PFR-057 Title: Misconnected ADC voltage reference on DFB

Assembly : IDPU	SubAssembly : DFB	
Component : ADCs (U36 and U42)	Units Affected:	Units fixed:
Originator: Chris Cully	<input checked="" type="checkbox"/> <input checked="" type="checkbox"/> <input checked="" type="checkbox"/> <input checked="" type="checkbox"/> <input checked="" type="checkbox"/> <input checked="" type="checkbox"/>	<input checked="" type="checkbox"/> <input type="checkbox"/> <input type="checkbox"/> <input type="checkbox"/> <input type="checkbox"/> <input type="checkbox"/>
Organization: LASP	Date: May 25, 2005	
Phone: 303-492-2905	Email : cully@colorado.edu

Figure 1: Gain as a function of temperature for the Vx channels on flight unit F3 (SN004). Gain is given as relative to the gain at 25 C.

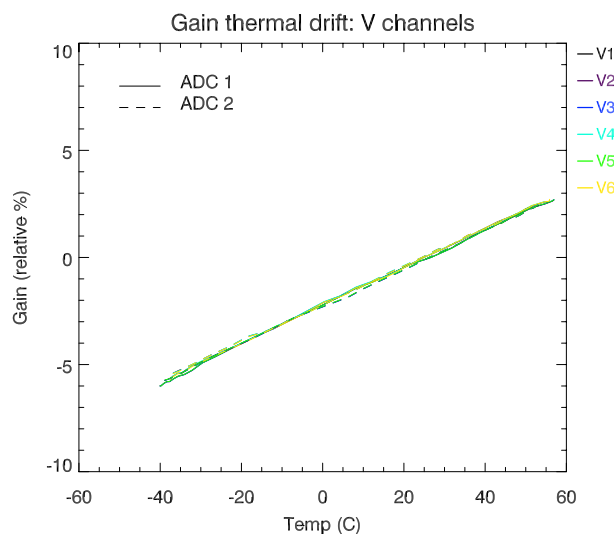
Testing of flight unit F3 (serial number 004) at LASP has revealed that the gains on all channels are strongly dependent on temperature. Results from this test for the Vx channels (i.e. +/-100V single-ended channels) are included here as figure 1.

All other channels showed similar results, as did flight board F2 (SN 003). The total drift of roughly 10% over the temperature range was not expected, and is out of the acceptable range given the science requirements.

Figure 2: In black: manufacturer's recommended setup for the LTC1604, using the 2.5V internal reference. In red: extra connection on ETU and flight boards.

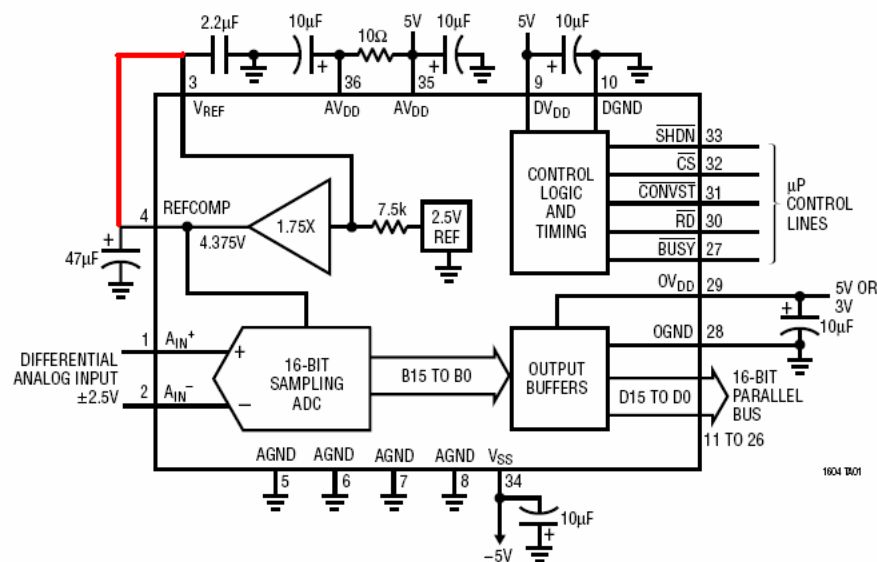
The recommended setup for using the internal 2.5V voltage reference on the LTC1604 A/D converter (from the manufacturer's data sheet) is sketched in black in figure 2. The circuit implemented on the ETU and flight boards is the same, except that it unintentionally includes the connection shown in red.

By connecting pins 3 and 4, the 1.75X amplifier is placed in an unstable configuration, with its output connected back to its input. The exact performance of the voltage reference circuit therefore depends on the details of the internal amplifier. Experimentally (by looking at the ETU), what happens is that pins 3 and 4 are driven to a voltage of roughly 4V, rather than the expected 4.375V. This drops the effective reference voltage from 2.5V to 2.3V, which explains the higher than expected gains. Furthermore, the effects of temperature/time/radiation on the circuit are unclear.

On the ETU, we consequently lifted pin 3 and allowed it to float. Although this isn't exactly equivalent to removing the red trace in figure 2, it did allow us to test the hypothesis that the feedback on the amplifier was causing the thermal drift problems. After lifting the pin, the voltages on pins 3 and 4 assumed the expected values of 2.5V and 4.375V, respectively. The gains for each channel also changed to what was originally expected.

Figure 3: Fragment of the schematic for the ETU, showing A/D1. Flight board schematic is identical in this section.

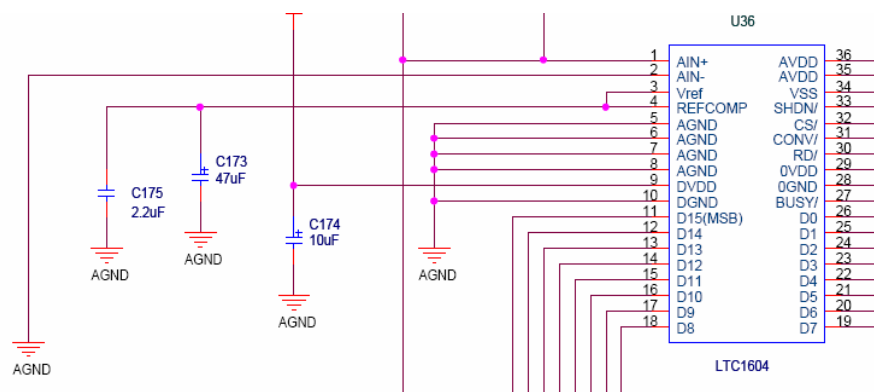
It is relatively straightforward to fix this problem on the flight boards. Figure 3 is a fragment from the schematic. On the board, the traces from pins 3 and 4 connect on the top layer, before going through a via that eventually connects to C175 and C173, as shown in figure 4.
